October 23, 2026

Re: 100% Remedial Design Report
Revised Conditional Approval Letter
G.T.E. Products Corporation Site
Site No.: 850003
Town of Seneca Falls, Seneca (C)

FIGURE 3

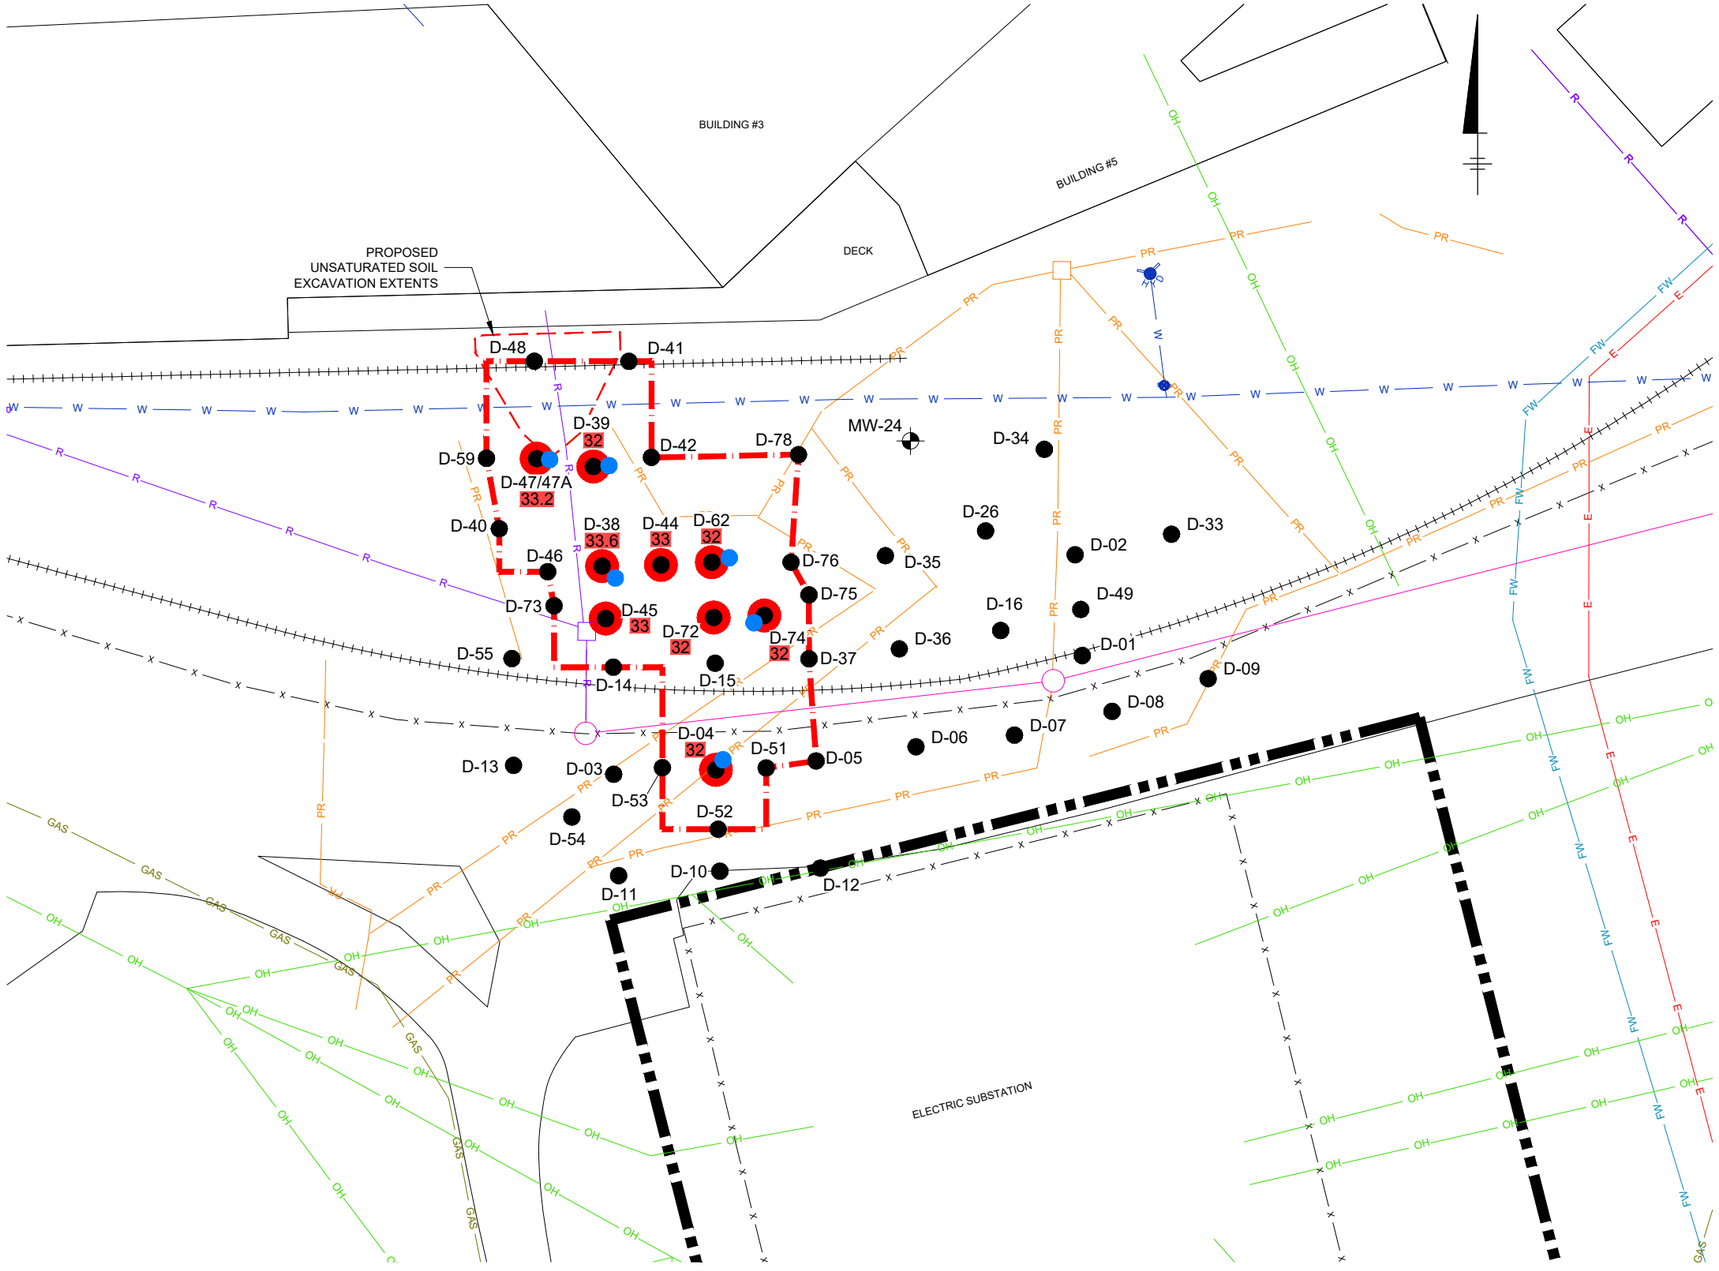
67. Figure 3: NYSDEC understands that the above grade SSDS piping will not be impacted during the ISTR heating activities.
